**SOIL/SITE EVALUATION**  
**for ON-SITE WASTEWATER SYSTEM**

Owner: *MRH land* Holding Applicant:  
 Address: *168 Wild Woodway* Date Evaluated: *11-4-2020*  
 Proposed Facility: *SFR* Design Flow (.1949): *760 GPD* Property Size:  
 Location of Site: *Same* Property Recorded:  
 Water Supply:  Public  Individual  Well  Spring  Other  
 Evaluation Method:  Auger Boring  Pit  Cut  
 Type of Wastewater:  Sewage  Industrial Process  Mixed

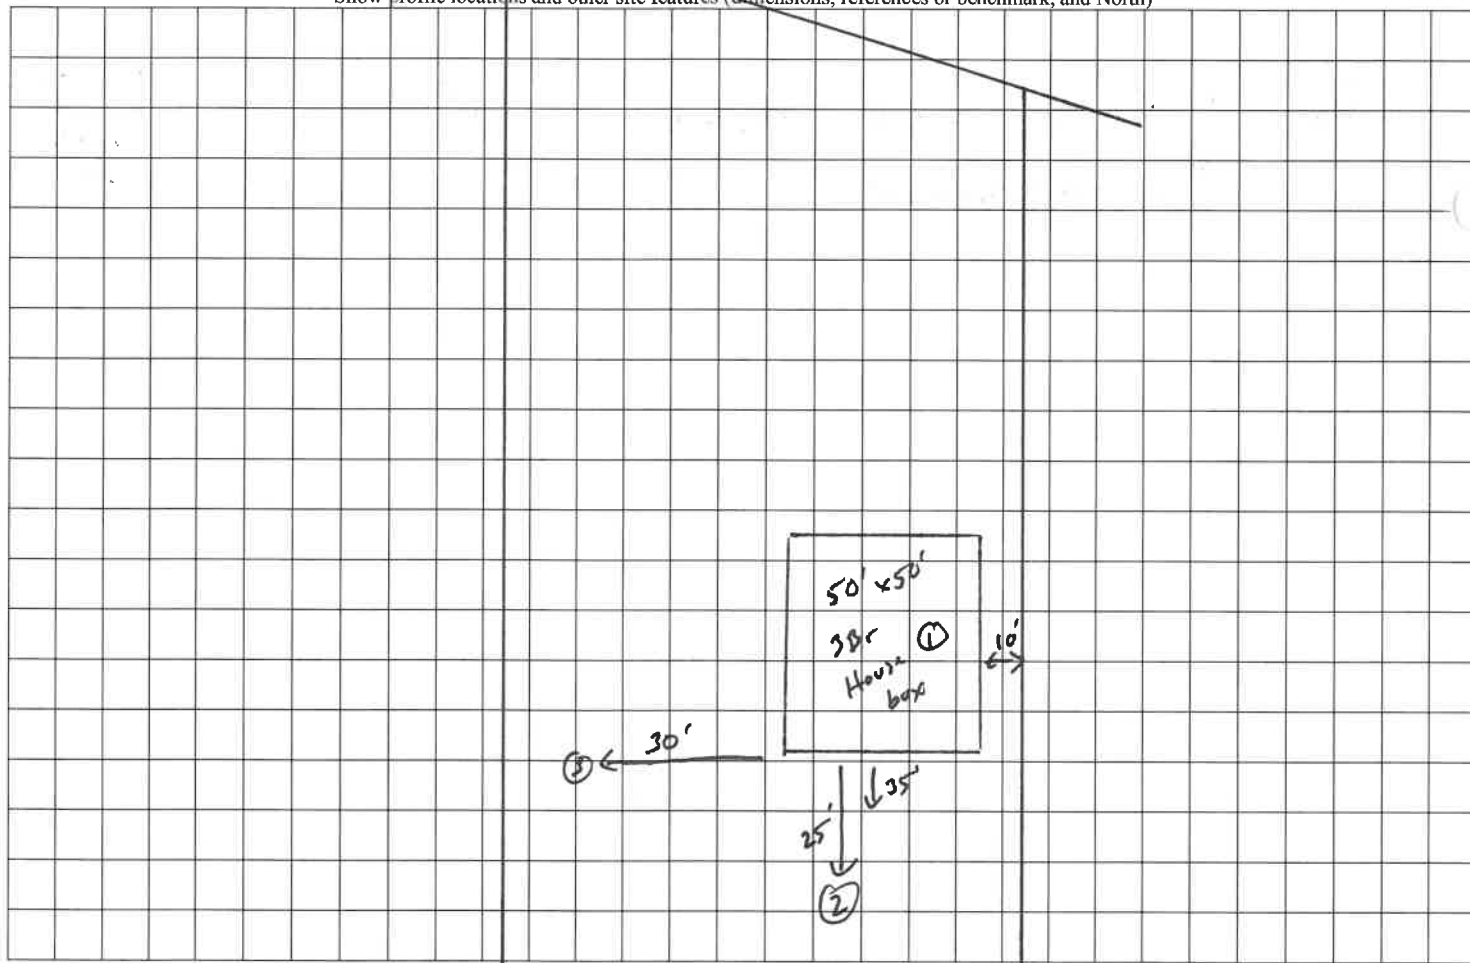
\* recommend move house  
 back by 40' to gain  
 access to suitable soils  
 for Drain Field + R.A.

Move hour box back as far as possible
